3rd Further Information

Proposed Temporary Open Storage of Construction Materials and Machinery with Ancillary Facilities and Associated Filling of Land and Pond for a Period of 3 Years in "Agriculture" Zone, Lots 1191 (Part), 1194, 1195, 1196, 1197 S.A (Part), 1197 RP (Part), 1198 S.C (Part), 1198 RP (Part), 1205 RP (Part) and 1208 in D.D. 109 and Adjoining Government Land, Kam Tin, Yuen Long, New Territories

(S.16 Planning Application No. A/YL-KTN/1184)

Response-to-Comment (RtC)

STANDARD MANHOLE
TYPE E1

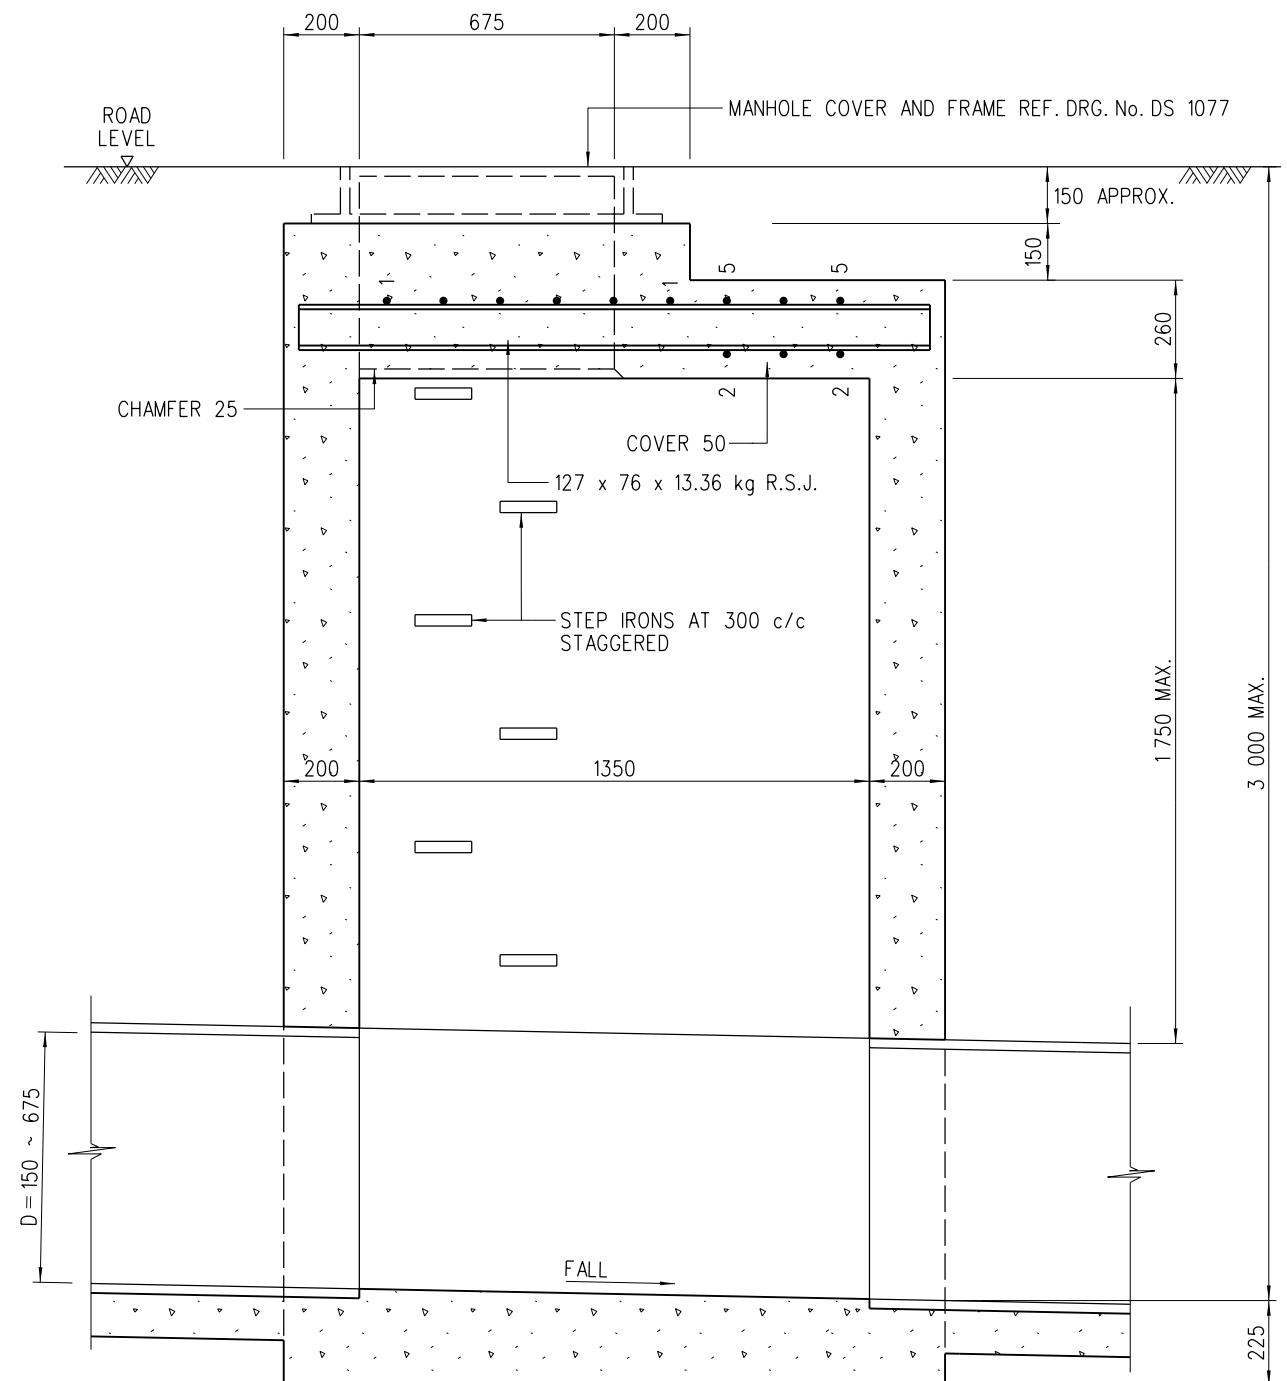
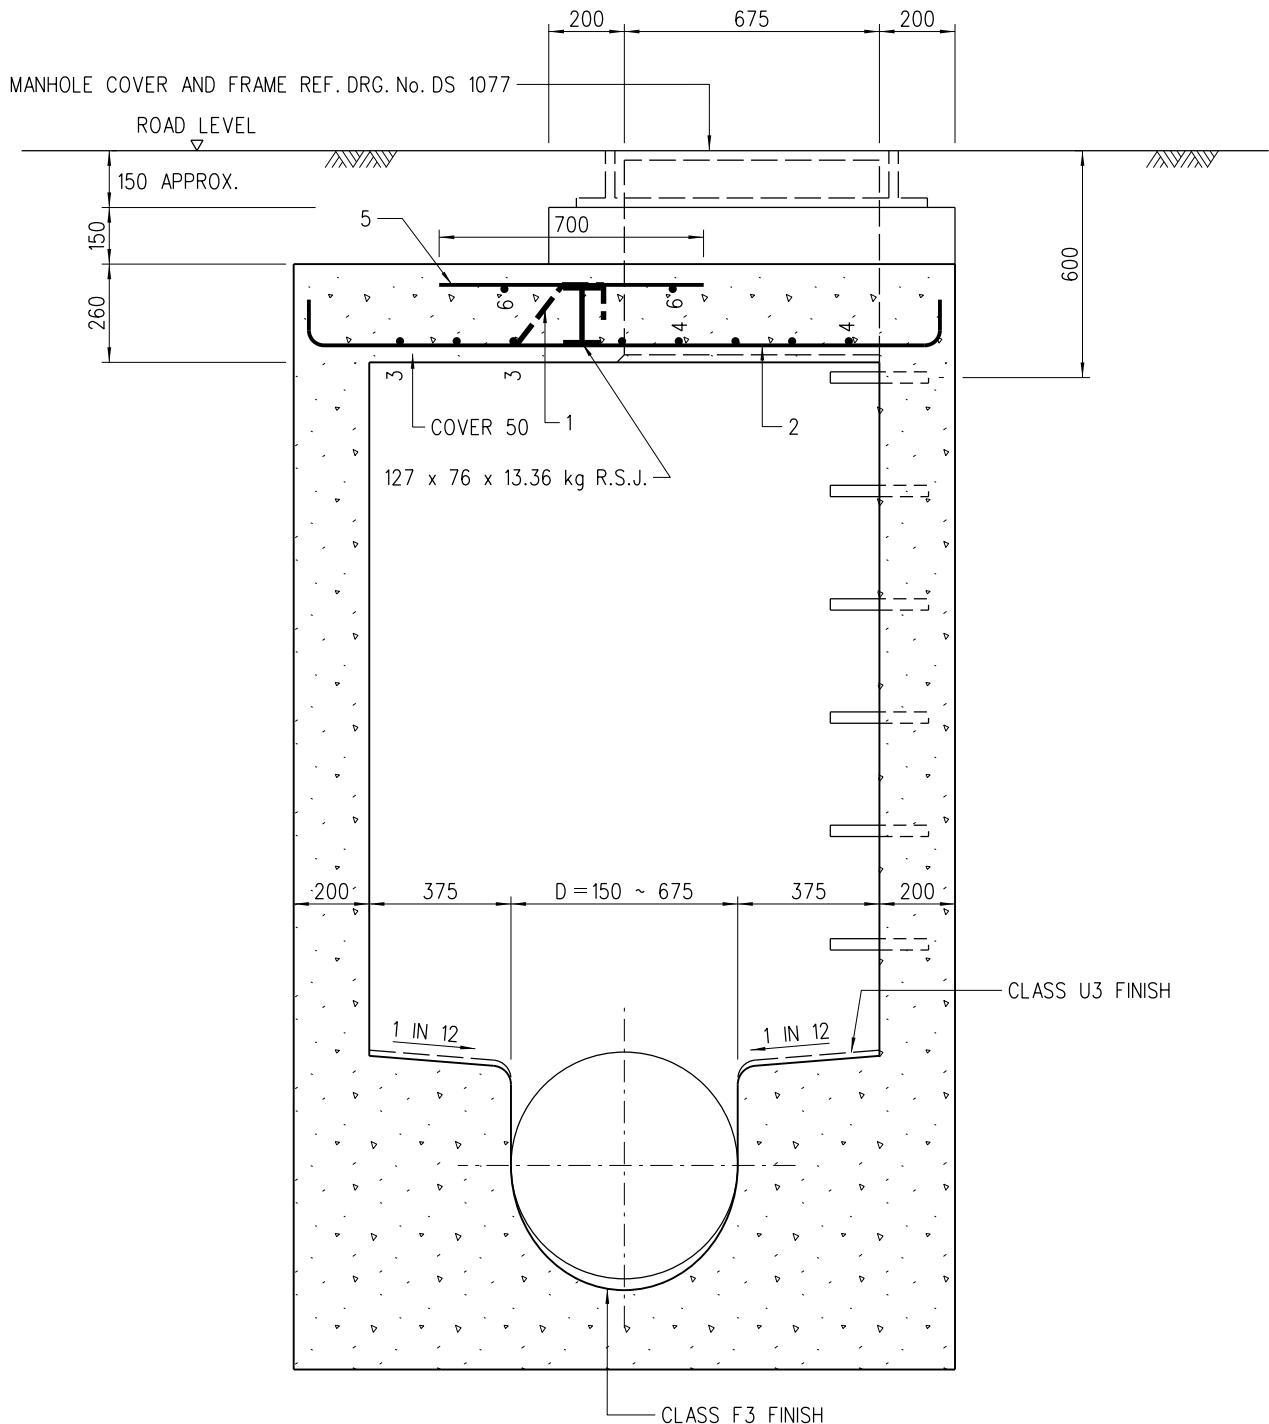
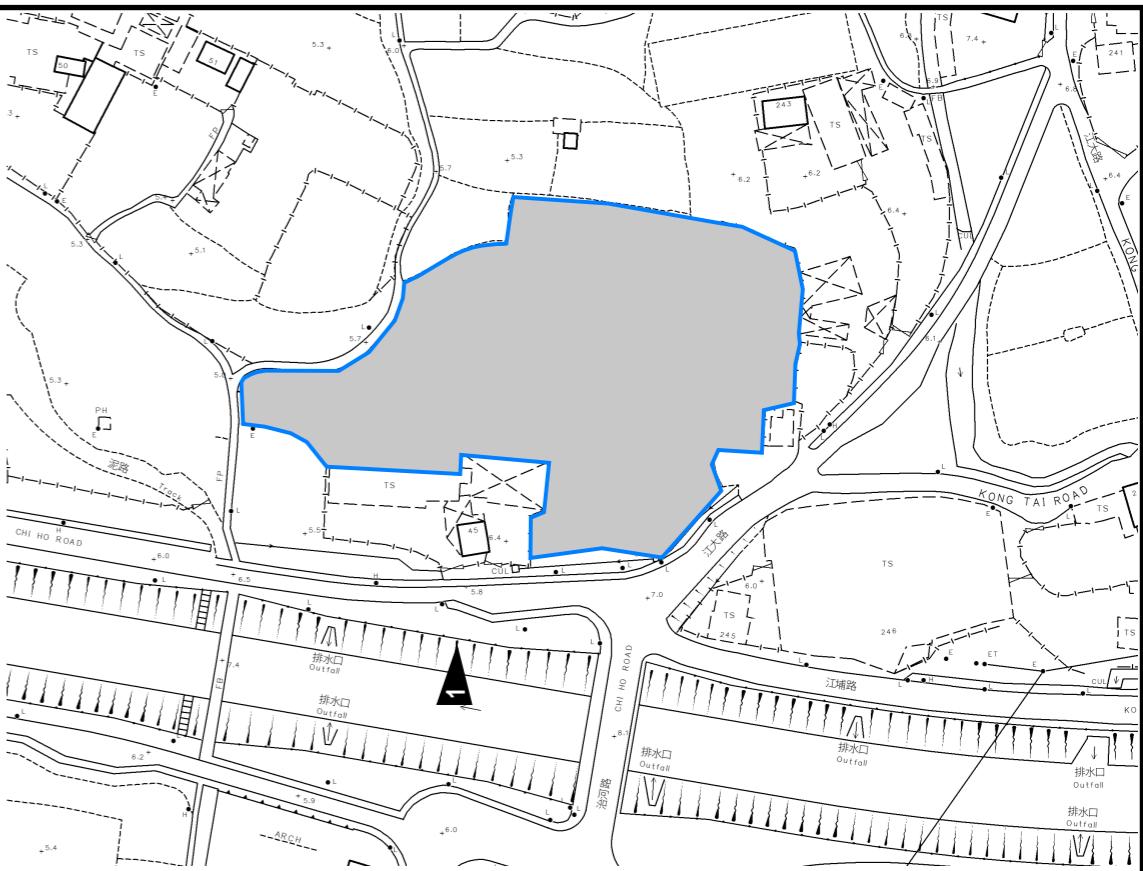
(k)	Catchpit should be provided where a proposed surface channel changes direction.	Noted.
(l)	Figure 3-2: The applicant should clarify type of the proposed drainage facilities i.e. 'E1'. shown in the schedule.	'E1' refer to standard manhole type E1. Standard drawings are enclosed at Appendix C of the revised drainage proposal.
